Current Zoning: B-1 (neighborhood business)  
Proposed Zoning: MUDD-O (mixed use development, optional) with three-year vested rights

Approximately 0.34 acres located at the southwest intersection of Seigle Avenue and Belmont Avenue, north of Harrill Street.

The petition proposes to rezone a lot previously used as an auto car garage to allow the construction of a 9,000-square foot mixed-use building residential and nonresidential uses.

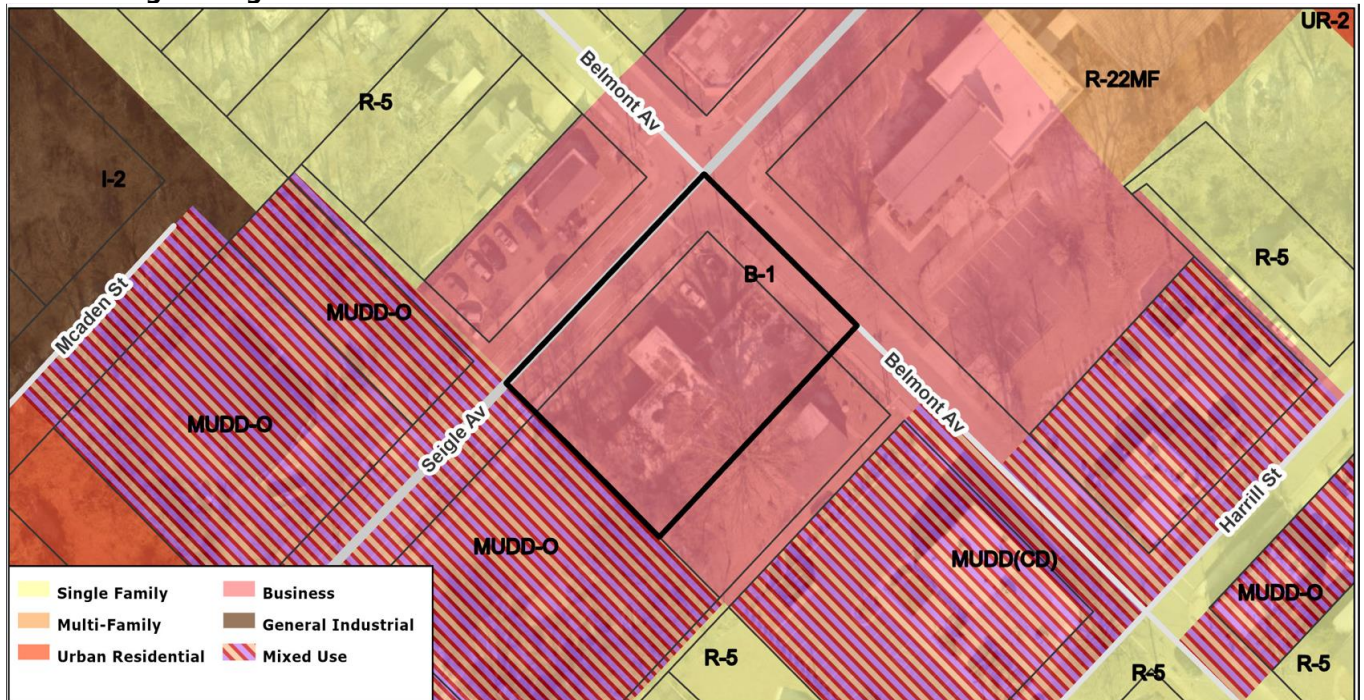
Existing curb and gutter can remain in existing location but label and dimension the future curb and gutter location from the centerline for each road on the site plan. Addressed

- ~~1. The site plan shall label and dimension the right of way from the road centerline. Site plan shows 25' to centerline but does not show the existing 50' from centerline. Label and dimension the existing 50' right of way from centerline of road.~~ Addressed

- ~~2. CDOT requests petitioner commit to 8' sidewalk and place Streets Map streetscape behind future curb location.~~ Addressed
- ~~3. Add a conditional note specifying "A Right of Way Encroachment Agreement is required for the installation of any non-standard item(s) (irrigation systems, decorative concrete pavement, brick pavers, etc.) within a proposed/existing City-maintained street right of way by a private individual, group, business, or homeowner's/business association. An encroachment agreement must be approved by CDOT prior to construction/installation. Contact CDOT for additional information concerning cost, submittal, and liability insurance coverage requirements."~~ Addressed

- ~~4. Add a conditional note specifying "the Petitioner shall dedicate and convey in fee simple all rights-of-way to the City before the site's first building certificate of occupancy is issued. CDOT requests rights-of-way set at 2' behind back of sidewalk where feasible."~~ Addressed

- ~~5. Petitioner should revise the site plan and conditional notes to show sidewalk utility easement on plans behind proposed sidewalk.~~ Addressed

6. ~~Petitioner should revise the site plan and conditional notes to show 10x10 triangles behind the sidewalk.~~ **Addressed**

7. ~~Review urban tree requirements. While the 10' no build zone can be counted towards tree save there must still be a minimum of 10' of replanted tree save. (20' total width) Trees cannot be planted within 10' of a structure/retaining wall. Utilities such as transformers are not permitted within trees save or amenitized tree save.~~ **Petitioner response:** Petitioner has reconfigured preliminary off-street parking layout to accommodate 10' distance & 10' width requirements. Potential transformer locations have been moved outside of amenitized tree save (See Site Plan on RZP-01, Rev 2). **Update:** Per discussion, the best option for tree save at this point will be provided per the ordinance and removed "potential tree save" designation for areas that we not sure would even qualify as tree save and review that during development plan review. **Addressed**

8. ~~Trees outside of the property line cannot count towards any requirements. Trees must be completely on the property to count towards requirements.~~ **Petitioner Response:** Petitioner commits to protecting the five "property line trees" on southern property line. (See Note 2D, RZP-01 Site Plan, Rev 2). Petitioner is open to amending the wording of this Optional Provision to suit Urban Forestry, if desired. Note: as provided to Henry Kunzig via 4-17-23 email, center measurement of 12" oak is completely on property at dbh. Updated Tree Survey uploaded to ACCELA. Petitioner is willing to reduce protection to just that tree, if desired. **Update:** While trees on the property line can be protected, trees not completely located on the property cannot be counted towards meeting tree save requirements. **Addressed**

9. ~~Please confirm if residential is proposed as it is not specified under proposed uses.~~ **Addressed**
10. ~~Under proposed list of permitted uses, please modify Type EDEE Types 1 and 2 to note subject to ordinance requirements.~~ **Addressed**
11. ~~Under proposed list of permitted uses, please modify breweries to note subject to ordinance requirements.~~ **Addressed**
12. ~~Include minimum % brick required on ground floor.~~ **Addressed**
13. ~~Include minimum area for public open space required.~~ **Addressed**
14. ~~The precedent imagery is showing a structure constructed with brick. Recommend brick being used as a primary building material on the first floor.~~ **Addressed**
